## REMARKS

Serial No.: 10/063,331

For: **INTEGRATED CIRCUIT WITH CAPACITORS HAVING A FIN STRUCTURE**  
(as amended herein)

**REQUEST FOR APPROVAL OF DRAWING CORRECTIONS**

FIG. 7b

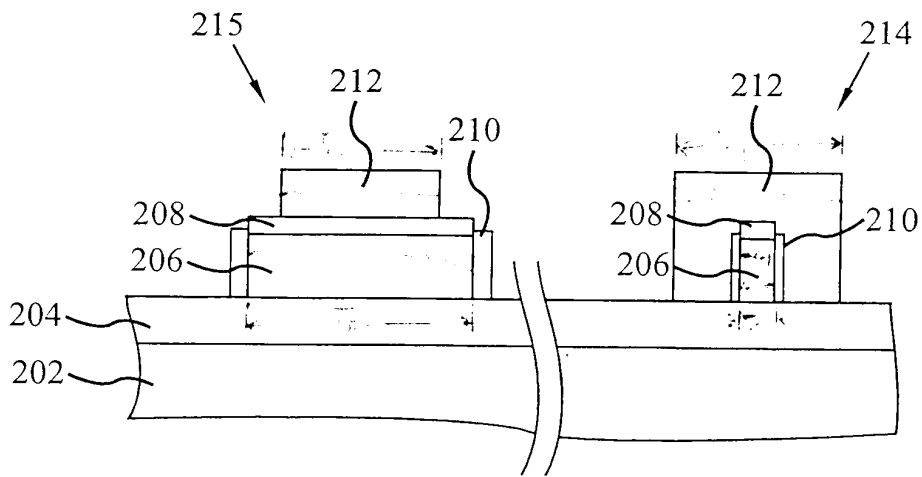
Figure	Item/Support
FIG. 7b	FIG. 7b merely adds symbols denoting various thicknesses.
FIG. 8	The FinFET 250 as being on the buried insulator 204 and being coupled (by the interconnect 240) at its gate electrode 255 to the gate electrode 212 of the capacitor 215 is disclosed in claim 8 of the originally filed patent application. The interconnects 241 and 242 are disclosed in claims 2 and 3 of the originally filed patent application.

FIG. 8

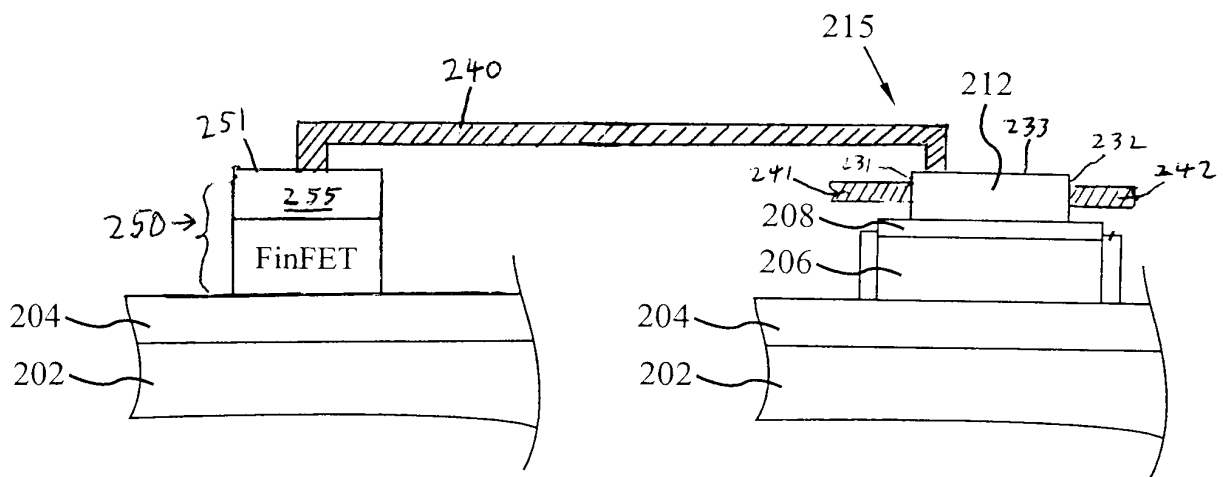
The Examiner alleged: “Claim 2, the phrase “at least one first interconnect disposed adjacent one of the top surface, the first side surface, and the second side surface of the at least one Fin structure” is not described in the specification and the figure.”

The Examiner alleged: “Claim 3, the phrase “at least one second interconnect disposed adjacent the at least one conductor structure” is not described in the specification and the figure.”

The Examiner alleged: “Claim 8, the phrase “a FinFET is disposed on the substrate, the FinFET having a gate electrode coupled to said conductor structure” is not described in the specification and the figure.”

The Examiner alleged: “Claim 10, lines 13-14, the phrase “the second conductor structure partially overlays is within a thickness of the second Fin structure” is not described in the specification and the figure.”

In response to the preceding allegations by the Examiner, Applicants have amended the drawings herein to add a new FIG. 8 which depicts the preceding subject matter alleged by the Examiner to not be depicted in the drawings. In addition, Applicants have described FIG. 8 in a new paragraph added herein by amendment. FIG. 8 and the new paragraph does not include new matter as shown in Appendix A and Appendix B.
